# Nonresidential HVAC Controls – March 2021 Addendum

**2022-NR-HVAC4-D | Nonresidential HVAC | March 2021**

**Addendum to FINAL CASE REPORT**

Prepared by Energy Solutions and Red Car Analytics

Figure 10: Dual Maximum Control Sequence with lower zone deadband (amended)

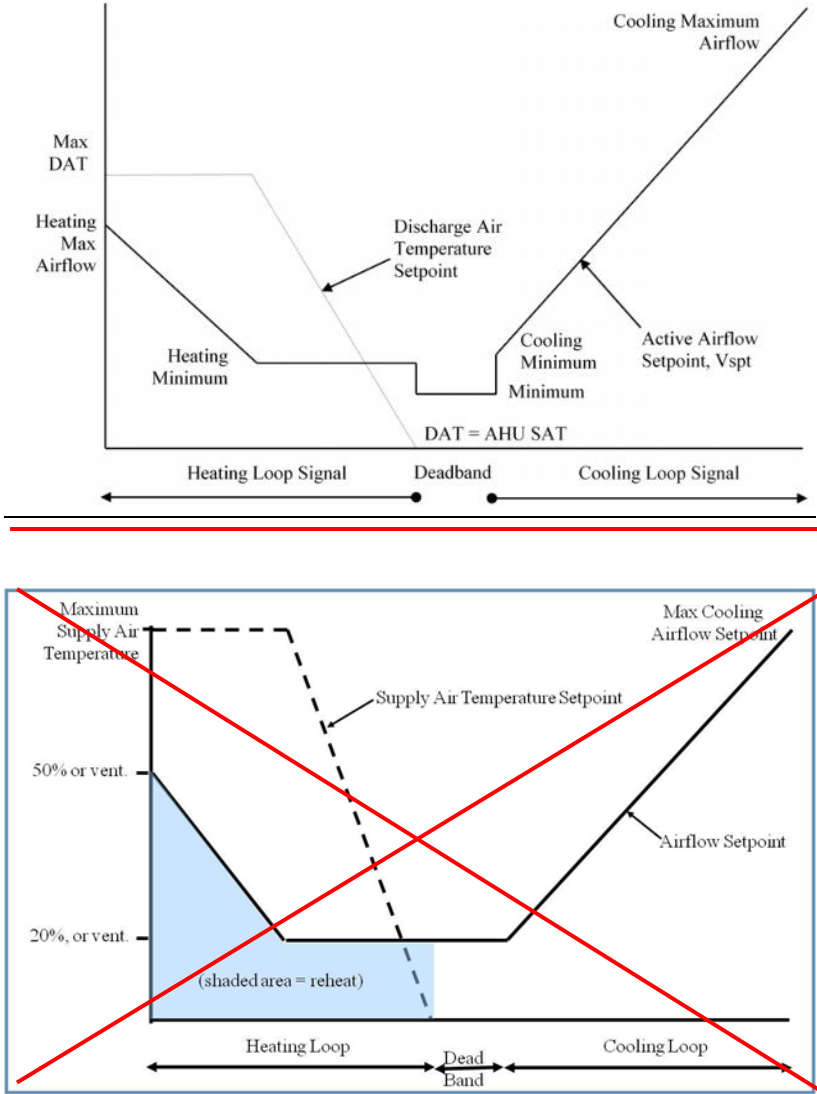
1. The first stage of heating consists of modulating the zone supply air temperature setpoint up to a maximum setpoint no larger than 95°F while the airflow is maintained at the dead band flow rate.
2. The second stage of heating consists of modulating the airflow rate from the dead band flow rate up to the heating maximum flow rate (50 percent of design flow rate).

Figure 1: Dual-Maximum VAV Box Control Diagram **with Lower Zone Deadband (amended)**

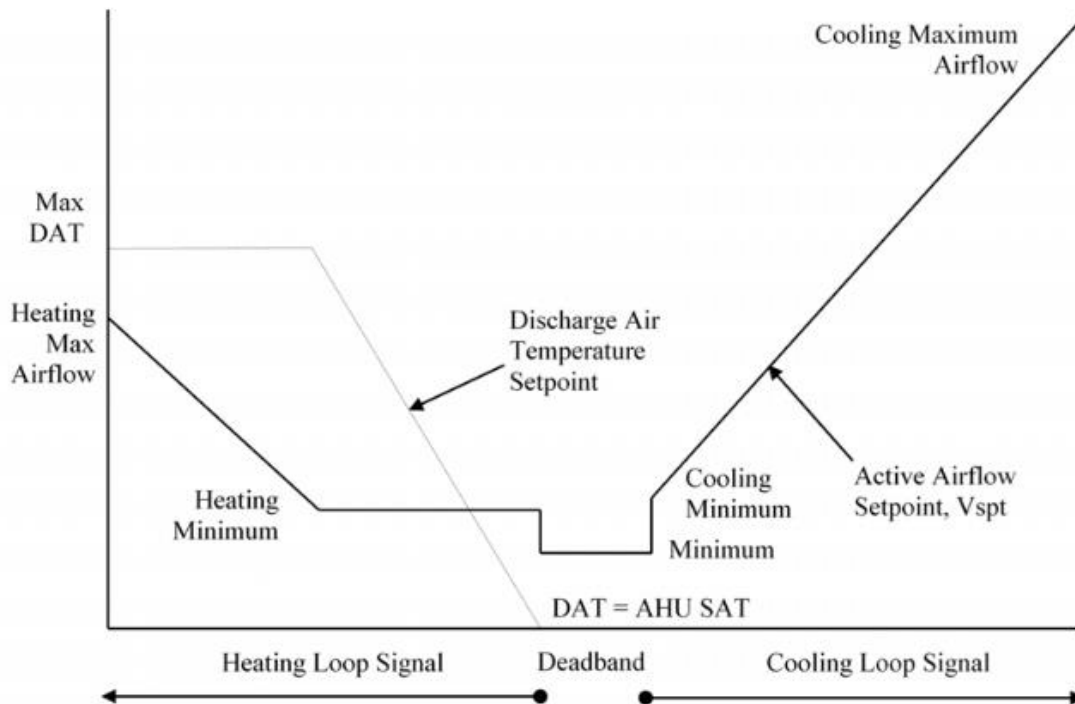
For systems with DDC to the zone level, the controls must be able to support two different maximums -- one each for heating and cooling. This control is depicted in Figure 1 below. In cooling, this control scheme is similar to a traditional VAV reheat box control. The difference is what occurs in the deadband between heating and cooling and in the heating mode. With traditional VAV control logic, the minimum airflow rate is typically set to the largest rate allowed by code. This airflow rate is supplied to the space in the deadband and heating modes. With the "dual maximum" logic, the minimum rate is the lowest allowed by code (e.g. the minimum ventilation rate) or the minimum rate the controls system can be set to (which is a function of the VAV box velocity pressure sensor amplification factor and the accuracy of the controller to convert the velocity pressure into a digital signal). As the heating demand increases, the dual maximum control first resets the discharge air temperature (typically from the design cold deck temperature up to 85 or 90 degrees F) as a first stage of heating then, if more heat is required, it increases airflow rate up to a "heating" maximum airflow set point, which is the same value as what traditional control logic uses as the minimum airflow set point. Using this control can save significant fan, reheat and cooling energy while maintaining better ventilation effectiveness as the discharge heating air is controlled to a temperature that would minimize stratification.

This control requires a discharge air sensor and may require a programmable VAV box controller. The discharge air sensor is very useful for diagnosing control and heating system problems even if they are not actively used for control.
